March 30, 2021

Re: Old Sudbury Road Culvert Replacements NOI  
Response to Comments

TO: Arthur Allen, EcoTec, Inc.  
PREPARED BY: Daniel Pasquale & Kevin Trainor, Woodard & Curran  
REVIEWED BY: Scott Salvucci, Woodard & Curran  
DATE: February 18, 2021 (revised March 30, 2021)  
RE: Old Sudbury Road Culvert Replacement (#110 & #149) – Hydraulic Analysis

EXISTING CONDITIONS PLAN -  
CULVERT 149

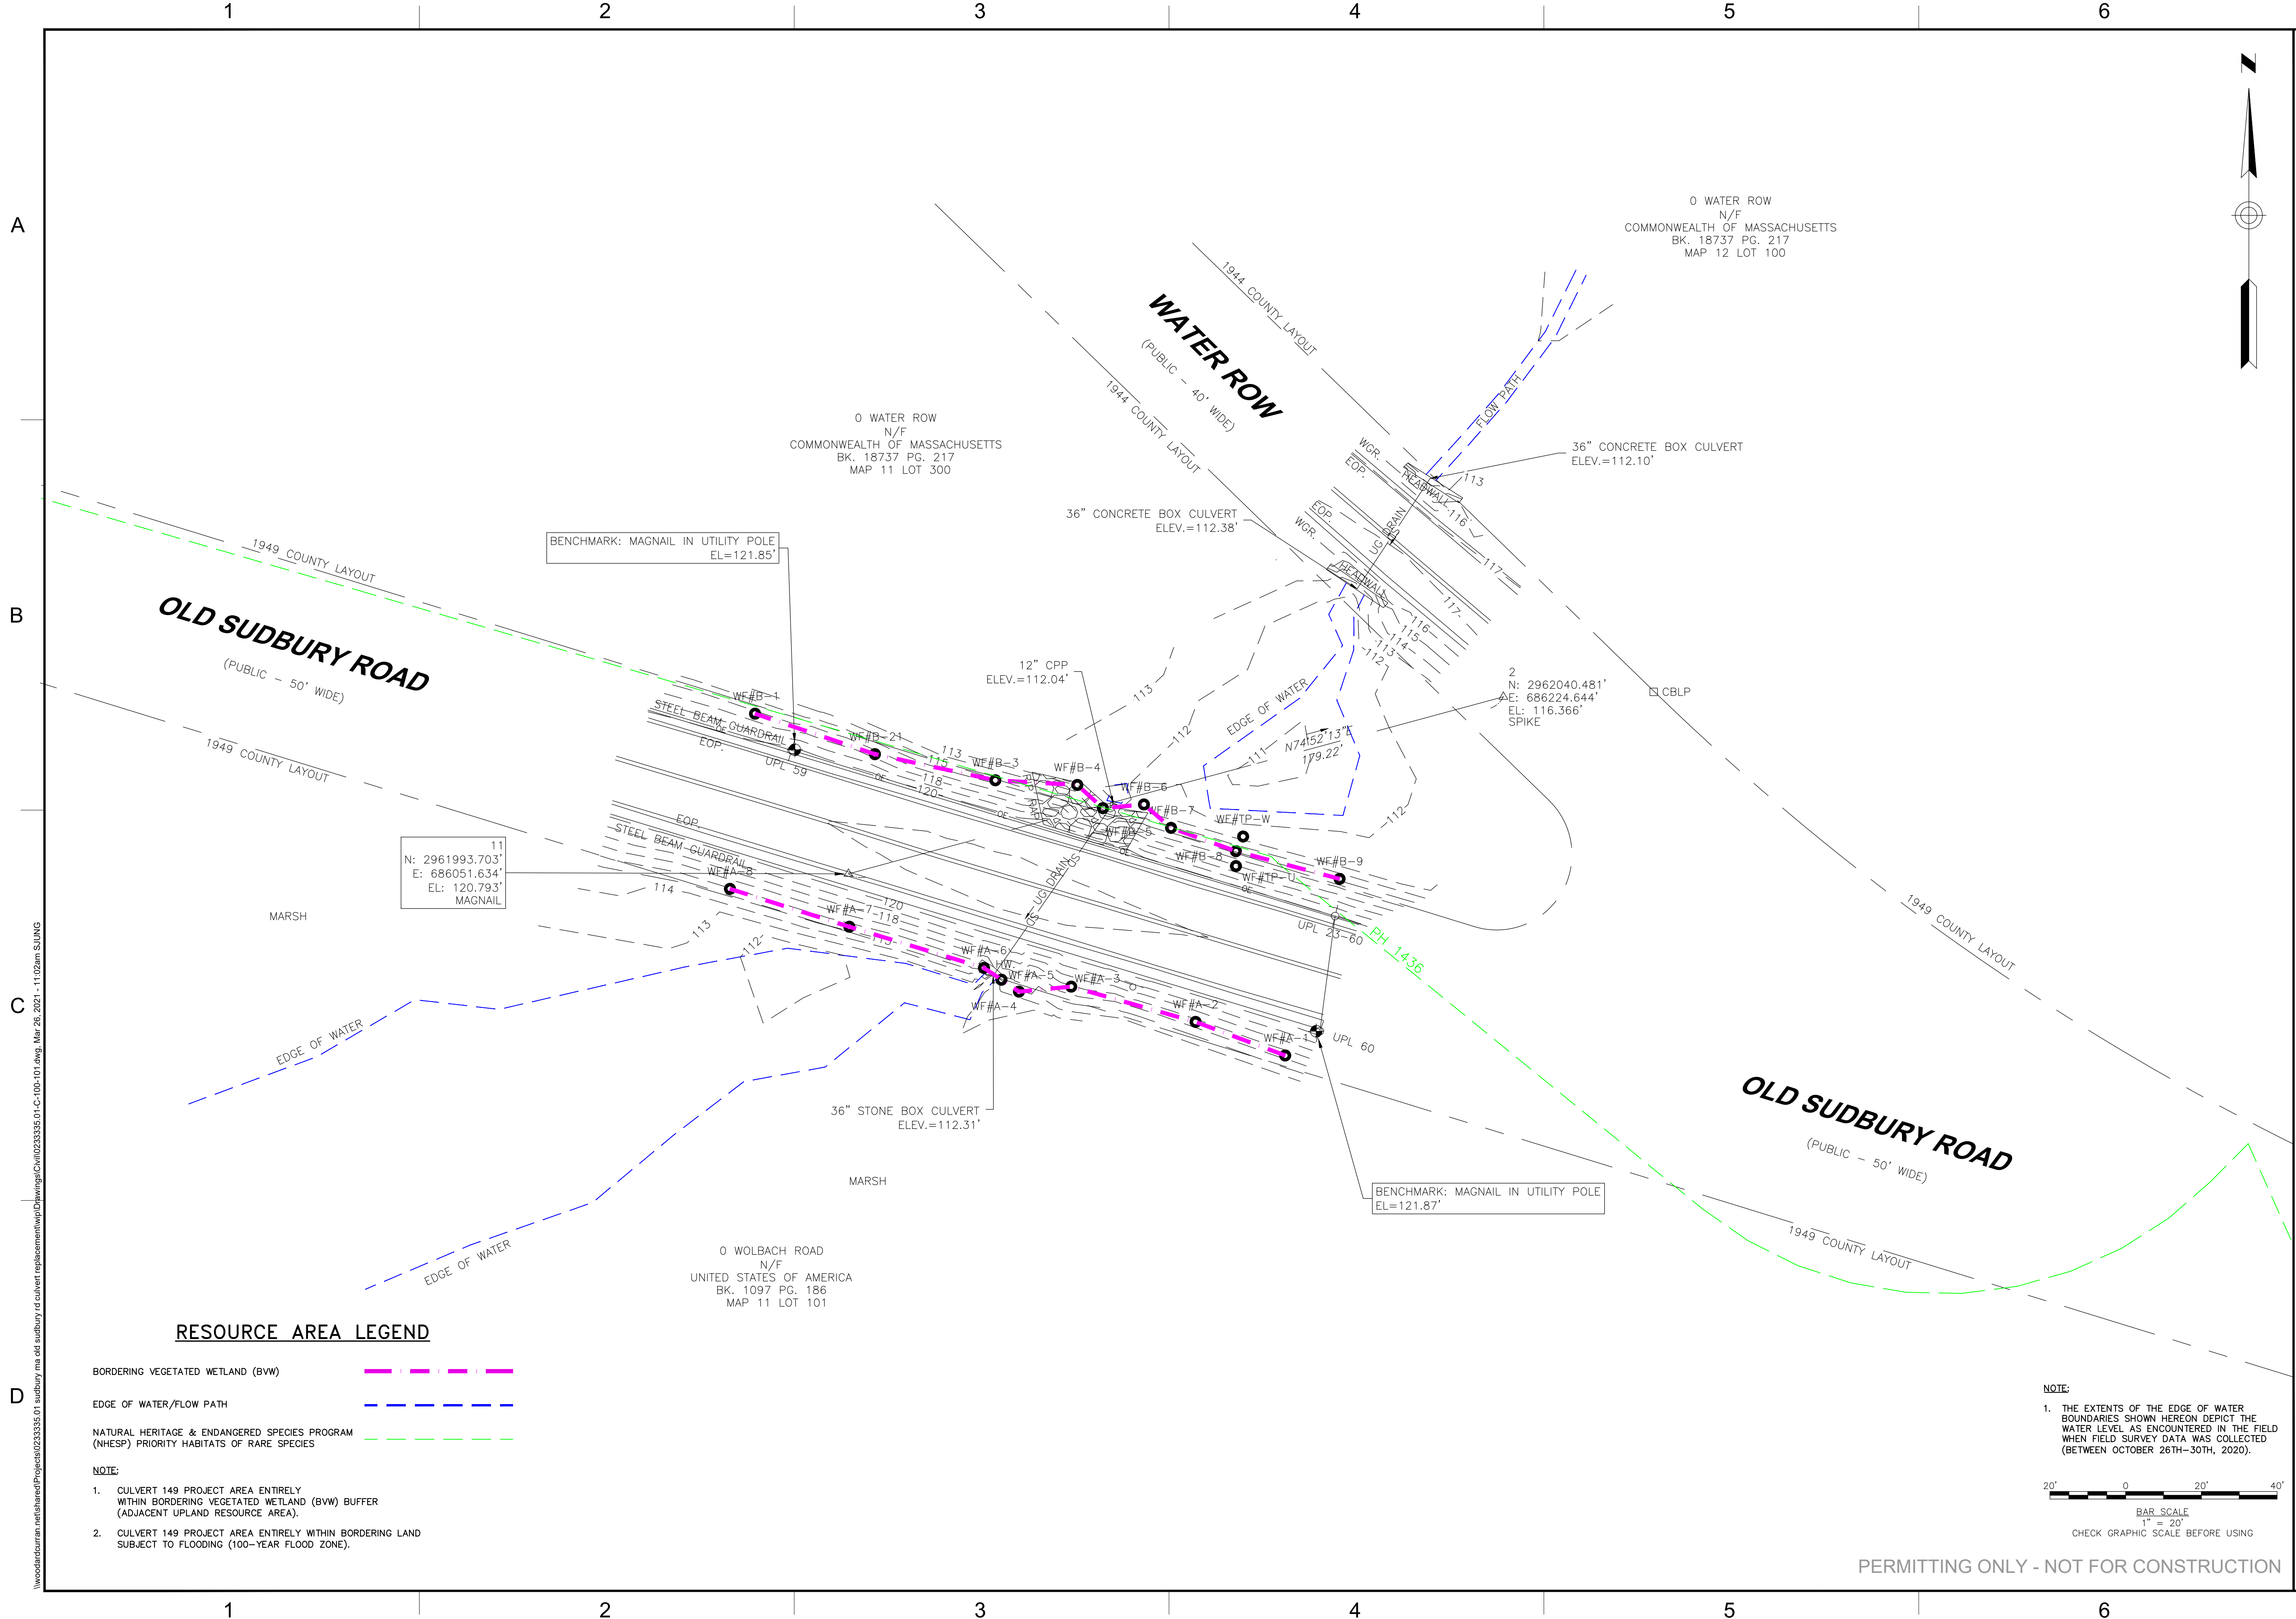
*Comment 4: The extent of the edge of water at culvert 149 does not reflect current conditions. Currently the outlet is completely submerged.*

Please see Note 1 on the revised Sheet C-101.

SITE PLAN AND PROFILE -  
CULVERT 149

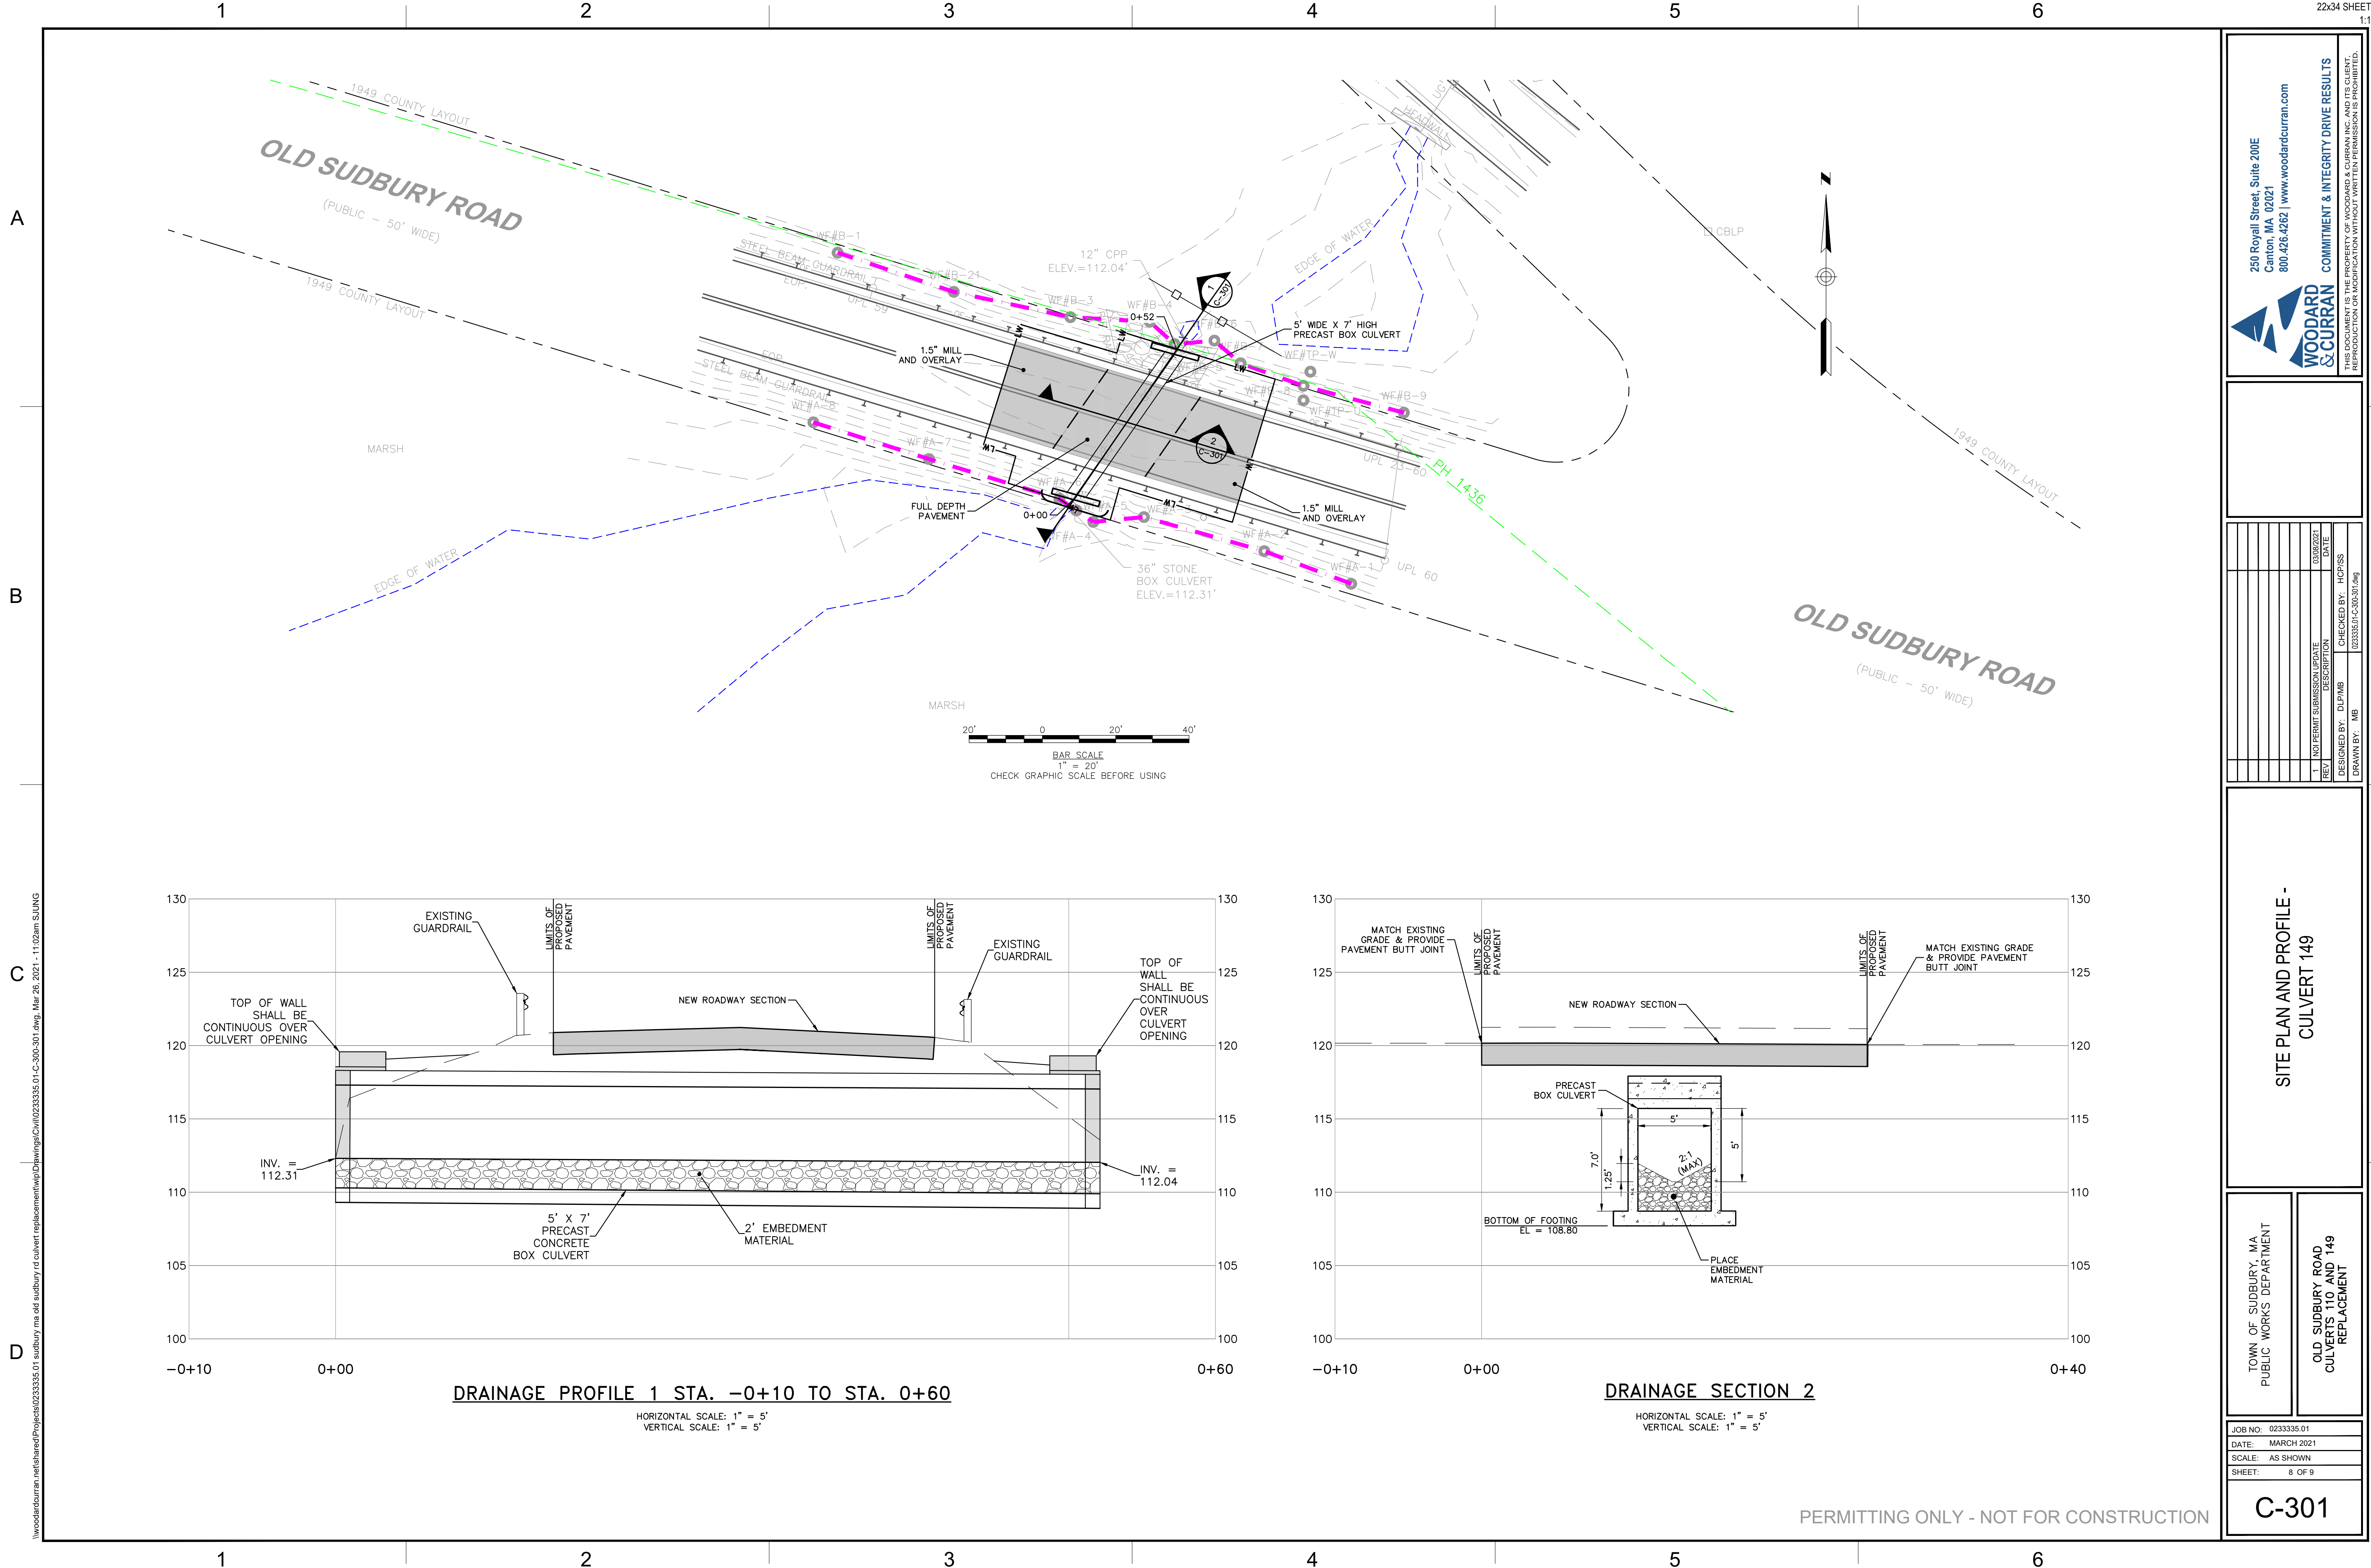
*Comment 3: Any cut and/or fill in BLSF for culvert 149 should be quantified, even if temporary. Is there any net increase in flood storage from proposed work?*

We have determined that relative to existing conditions, flood storage volume at Culvert 149 will increase by approximately 93 cubic feet.

FIG-5

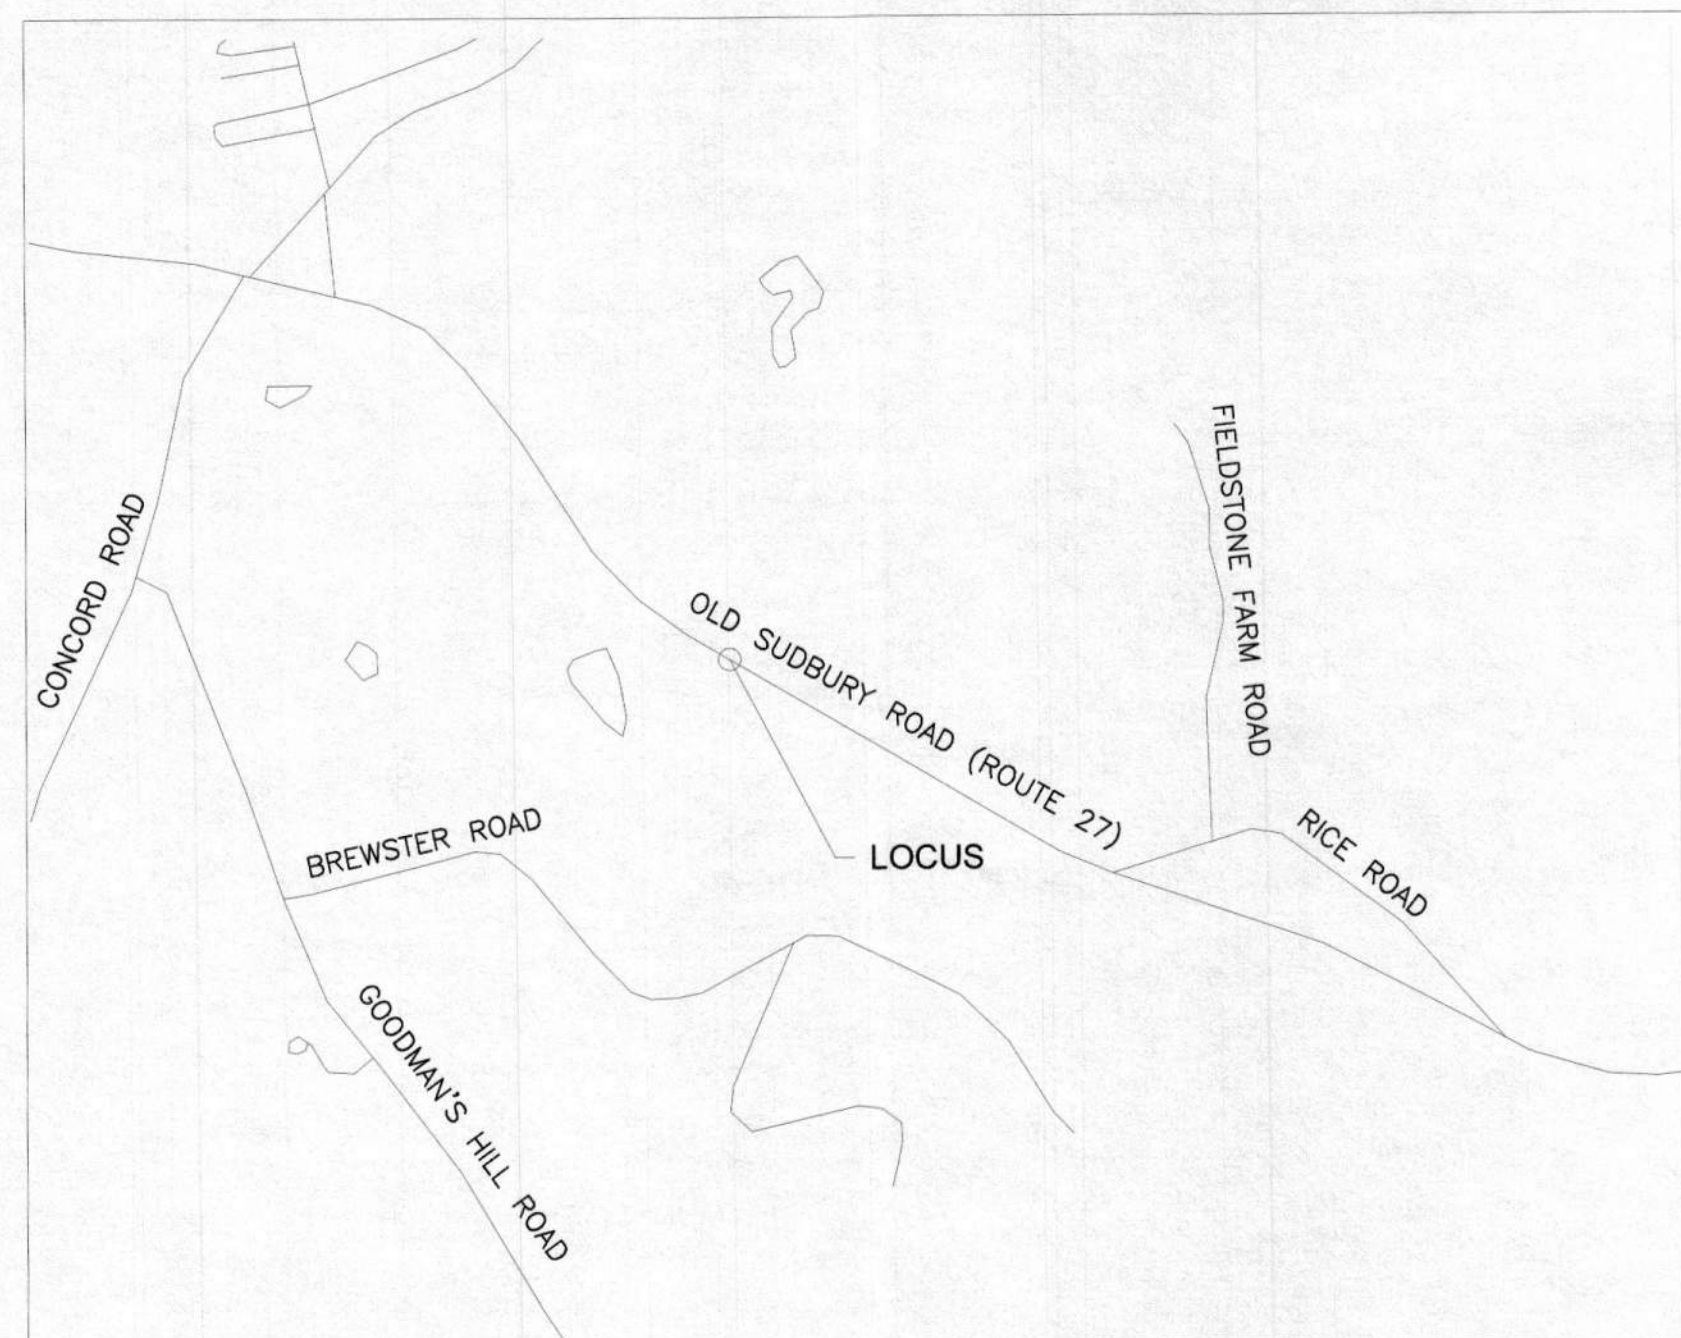
Comment 13: ***Figures 6 and 7 are titled "Old Framingham Rd Sidewalk Extension"***

Please see the revised impact figures, re-numbered 5 and 6, with revised titles.
